STAFF REPORT
COMMUNITY DEVELOPMENT DEPARTMENT

SUBJECT: FP-2022-0005
Graycliff Estates No. 2

LOCATION: 684 W. Harris St., in the SE ¼ of Section
25, Township 3N., Range 1W.

Final plat consisting of 54 buildable lots and 6 common lots on 13.26 acres of land in the R-8 zoning district for the second phase of Graycliff Estates Subdivision.

B. Final Plat (dated: 1/6/22)

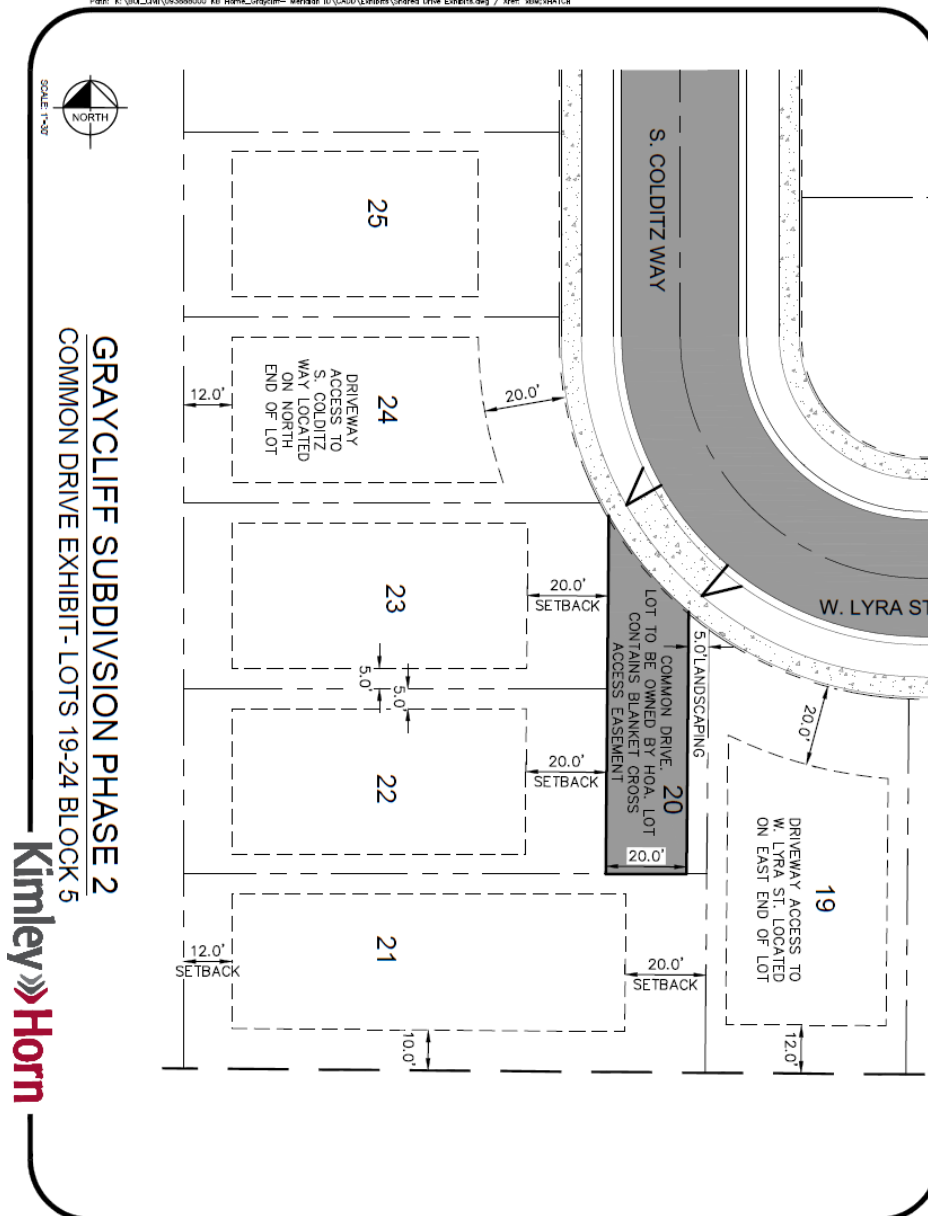
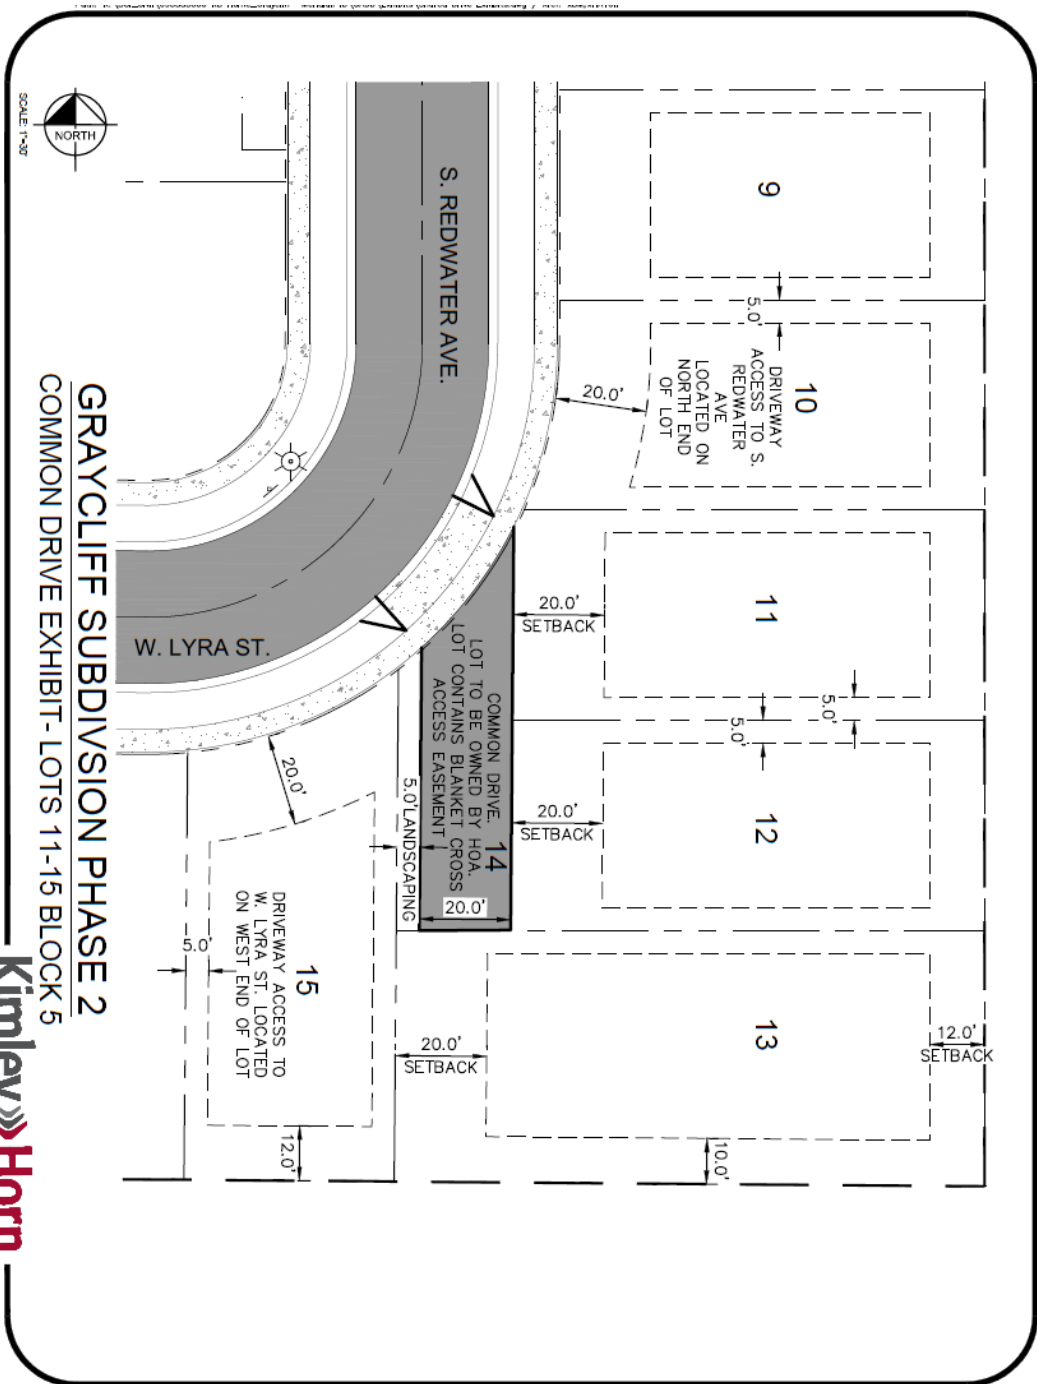
3. Prior to submittal for the City Engineer's signature, have the Certificate of Owners and the accompanying acknowledgement signed and notarized.
4. The final plat prepared by Land Solutions, stamped by Clinton W. Hansen, dated: 1/6/2022, included in Section V.B shall be revised as follows:

- a. Note #8: “. . . Lot 1, Block 27 is reserved for a City of Meridian well lot. Lot 2, Block 27 is reserved for a City of Meridian Park, unless the City Council determines a public park is not preferred in this development. . . .”

- b. Graphically depict the ACHD storm water drainage easements referenced in Note # 9.
 - c. Note #12: Include the recorded instrument number for the CC&R's.

- d. Add note: “The bottom of structural footing shall be set a minimum of 12-inches above the highest established normal ground water elevation.”
 - e. Include the recorded instrument number for the ACHD permanent easement line noted in the Legend.

- f. Include the recorded instrument number for the existing ACHD permanent easement graphically depicted on the plat.
 - g. Depict the public pedestrian easement for the multi-use pathway across Lot 2, Block 7 and include the recorded instrument number for the easement.

A copy of the revised plat shall be submitted with the final plat for City Engineer signature.
